City of West Linn Pre-Application Conference Summary

Upper Midhill Subdivision (34 lots) (PA-14-21)

Location: 21E 14CA tax lot 200 (1800 Upper Midhill Drive)

April 17, 2014

Reeseaman Property
Conceptual Subdivision Plan

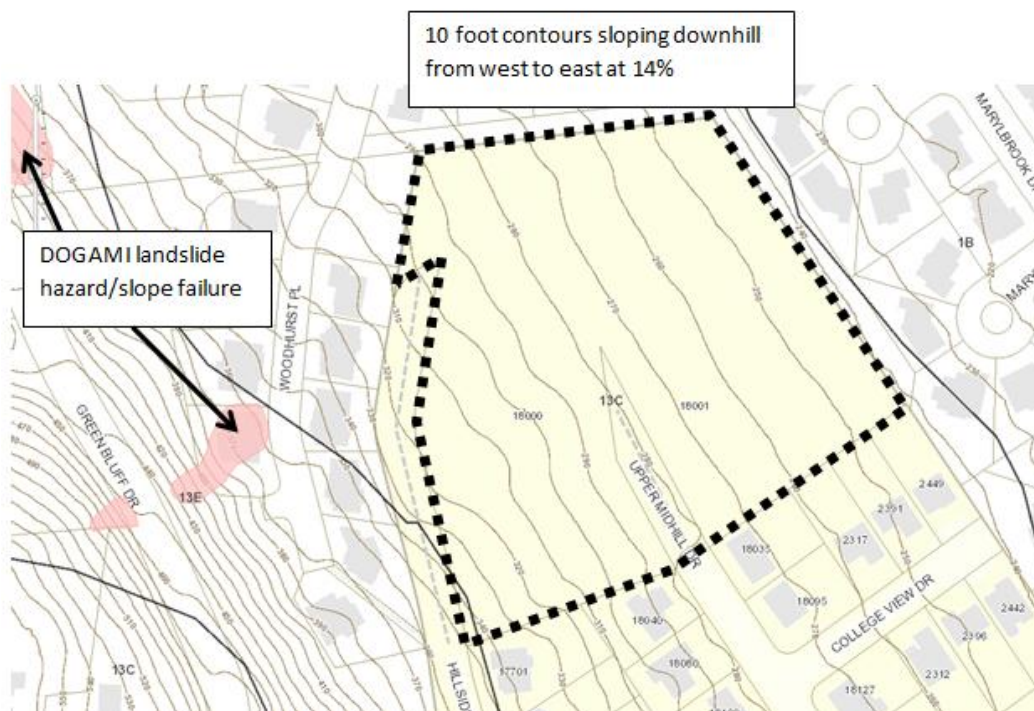
The applicant's preliminary plan for the site shows Upper Midhill Drive extending through the site and exiting the property via the Hillside Drive right of way. The lots are all over 4,500 square feet. The lot size would indicate that single family detached housing is proposed although the applicant has stated that they are considering all options.

Beginning with a gross area of 266,726 square feet we subtract about 30,000 square feet of net additional ROW proposed on the conceptual subdivision plan (after some ROW has been vacated and new ROW added) to yield a net developable square footage of 236,726 square feet. Seventy percent of 236,726 is 165,708 square feet which is then divided by the underlying R-4.5 zone's minimum lot size of 4,500 square feet to produce 36 lots. Therefore, the proposed density of 34 lots is two lots below the required density. The applicant could address that discrepancy by subtracting any open space areas dedicated to the City and/or the storm detention and treatment facility or by increasing the number of lots.

Currently, the undeveloped Upper Midhill Drive right of way extends 285 feet northwards into the property. This ROW length does not agree with the applicant's proposed ROW length which would extend only about 150 feet onto the property. The applicant asked if the subdivision process is an appropriate and legal vehicle to eliminate existing ROWs. Staff has reviewed this and whereas lot lines may be eliminated in the course of a new subdivision plat, dedicated ROW is not vacated by any means other than per ORS 271. (That process requires all abutting property owners adjacent to the ROW to support the vacation and the support of owners of 66.6% of property in the affected area.)

Ideally, this subdivision would connect to Lake Oswego at the northwest corner of the site via Woodhurst Place. However, there are two intervening properties, owned by Marylhurst Place Homeowners Association, which would have to be acquired to make that connection. It is not anticipated that the association would support or offer their property for that purpose. Still, it is possible that the existing dirt footpath from Woodhurst Place to the subject site could be used to provide pedestrian and bicycle connectivity. Access near lot 15 would facilitate that.
